INITIAL EXPRESS TERMS

FOR
PROPOSED BUILDING STANDARDS
OF THE
CALIFORNIA STATE LANDS COMMISSION

REGARDING PROPOSED CHANGES TO
THE 2019 CALIFORNIA BUILDING CODE,
CALIFORNIA CODE OF REGULATIONS, TITLE 24, PART 2

CHAPTER 31F – MARINE OIL TERMINALS
CHAPTER 35 – REFERENCED STANDARDS

FIGURE 31F-2-1

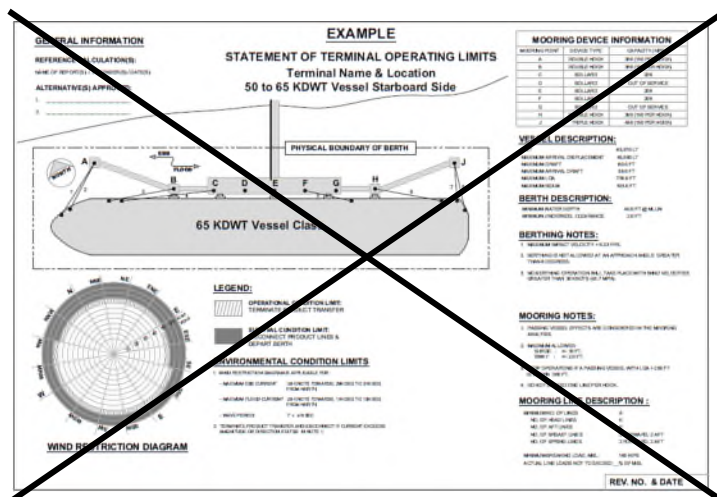
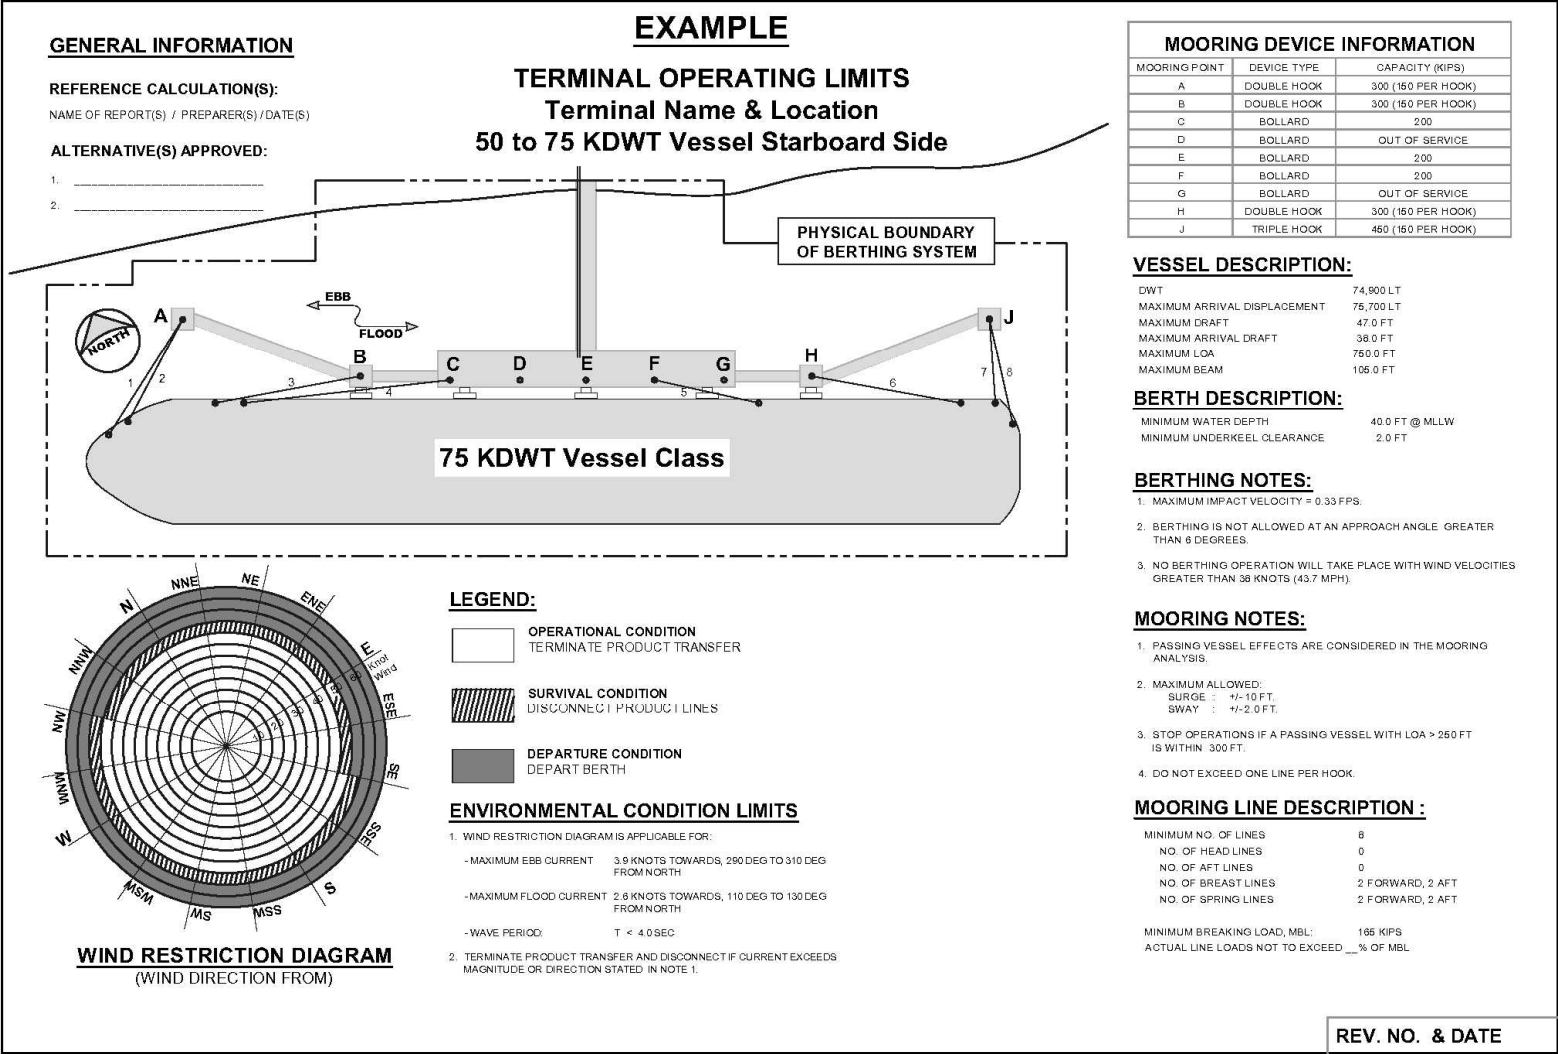
- 2.7. Remove entirely Figure 31F-2-1:**

2.8. Replace Figure 31F-2-1:

FIGURE 31F-4-5

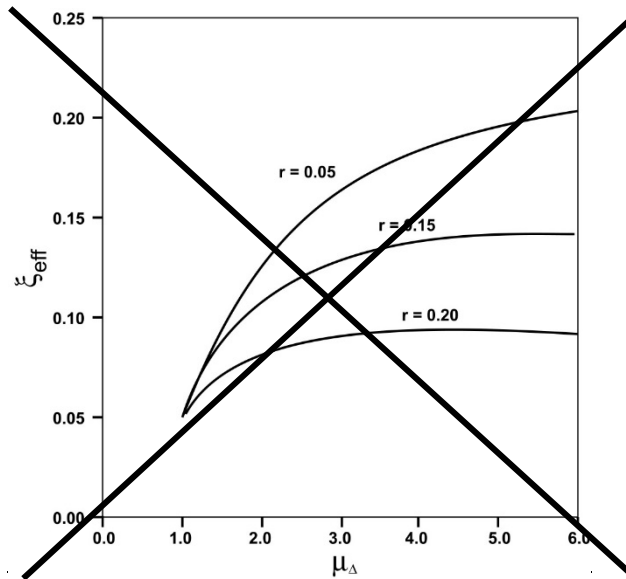
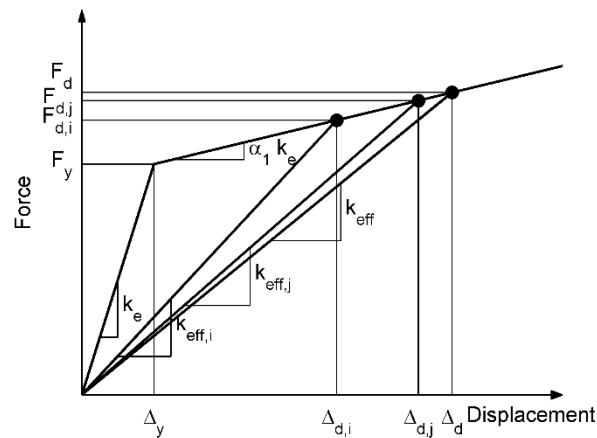
4.8. Remove entirely:

4.9. Add new Figure 31F-4-5:

FIGURE 31F-4-6
DESIGN DISPLACEMENT RESPONSE SPECTRA

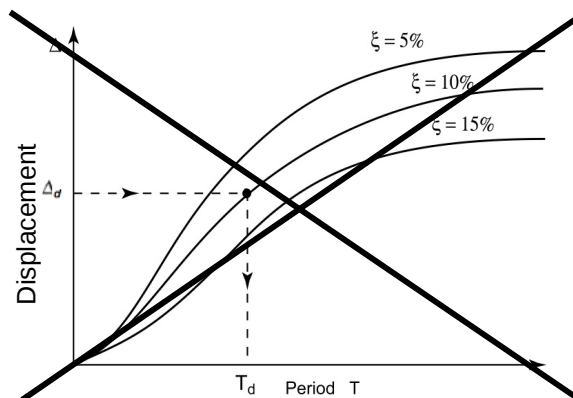
4.10. Remove entirely:

FIGURE 31F-4-7
EFFECTIVE LATERAL STIFFNESS (ADAPTED FROM [4.4])

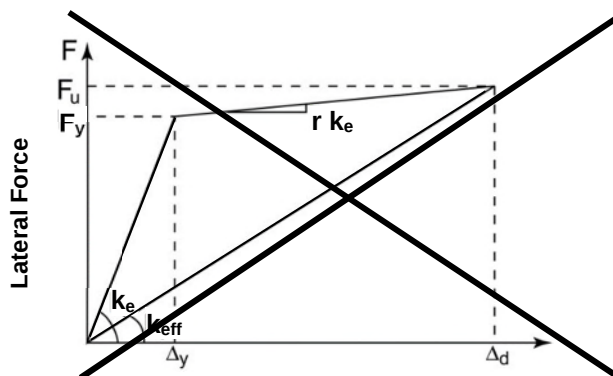
4.11. Remove entirely:

FIGURE 31F-4-9
AMPLIFICATION FACTOR, a_p [4.10]

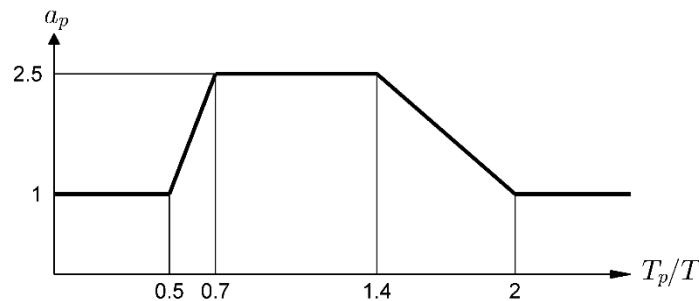
4.30. Add new Figure 31F-4-9:

FIGURE 31F-7-4
METHOD A – MOMENT CURVATURE ANALYSIS

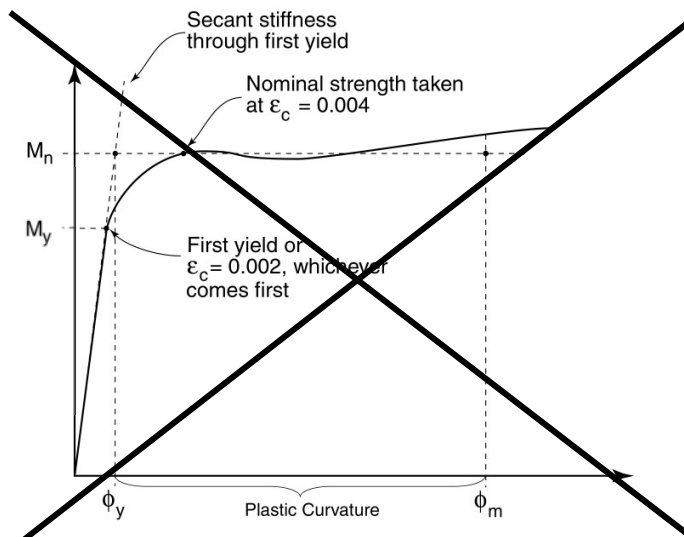
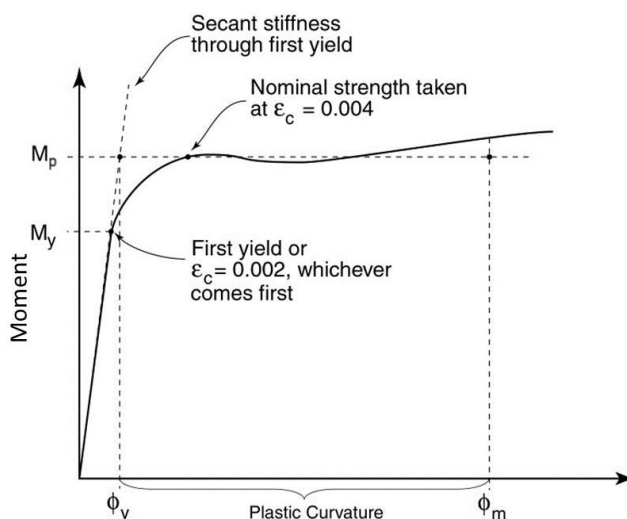
7.7. Remove entirely:

7.8. Add new Figure 31F-7-4:
